UNITED STATES PATENT AND TRADEMARK OFFICE

APPLICATION NO.	FILING DATE	FIRST NAMED INVENTOR	ATTORNEY DOCKET NO.	CONFIRMATION NO.
10/715,412	11/19/2003	Toshiro Kobayashi	2003-1495A	5320

Office Action Summary

DETAILED ACTION

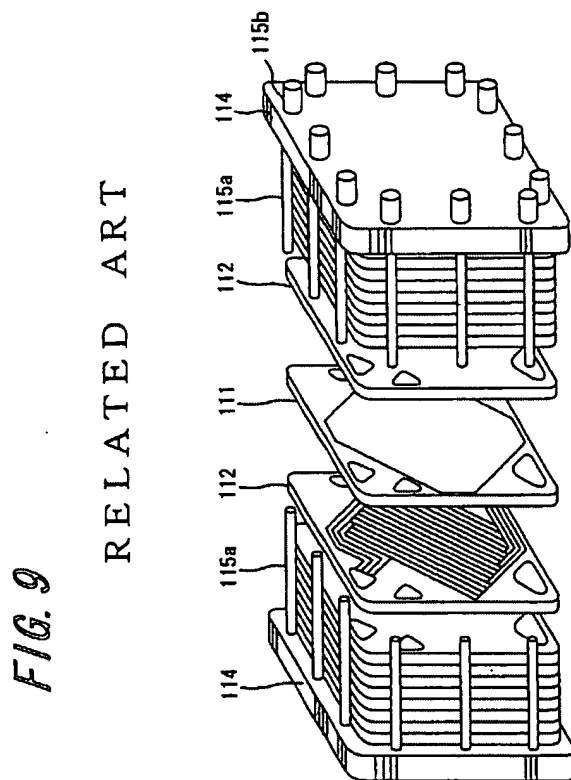
The AAPA illustrates in **Figure 9** below a stacked fuel cell comprising many cell films 111 and many separators 112 stacked alternately; the cell films 111 each comprising a solid polymer electrolyte film sandwiched between electrode films; the separators 112 each having electrical conductivity and having a fuel gas channel formed in one surface thereof and an oxidant gas channel formed in the other surface thereof (Applicant’s Background of the Invention, paragraph bridging pages 1-2).

(*Emphasis furnished*→) The AAPA reveals that the periphery of the resulting stack is clamped by threaded shafts 115a and nuts 115b via end plates 114. Shafts 115a pass through

piercing portions (*penetrate through holes or make a way through the holes*) of the many separators 112 interposed therebetween and end plates 114 (Applicant's Background of the Invention, paragraph bridging pages 1-2). *Note that shafts 115a is accommodated at a direction \perp to the stacking direction of cell films 111 (See FIGURE 9). Shafts 115a and nuts 115b comprise at least the line-shaped fastener. In this case, either the separators themselves or the end plates can be interpreted as the plurality of partition plates.*

The AAPA discloses many separators 112 and end plates 114 (Applicant's Background of the Invention, paragraph bridging pages 1-2/ See FIGURE 9). *In the instant case, under a first interpretation, the combination of a separator plate and an plate corresponds to the partition plate and the terminal board, respective. Thus, they acts as first and second members. Under a second interpretation, any separator plate itself may be the end separator and the terminal board. Reason why, applicant's embodiment of Figure 7b contemplates an integrated separator and a terminal board. Thus, the disclosed separator of the AAPA can be taken as the integrated separator and terminal board because there is no specific limitation in claim 3 to require that the separator and the terminal be separated.*

The AAPA reveals that the periphery of the resulting stack is clamped by threaded shafts 115a and nuts 115b via end plates 114. Shafts 115a pass through piercing portions (*penetrate through holes or make a way through the holes*) of the many separators 112 interposed therebetween and end plates 114 (Applicant's Background of the Invention, paragraph bridging pages 1-2). *Shafts 115a and nuts 115b comprise at least the line-shaped fastener which fast together the cells 111 and separators 112.*
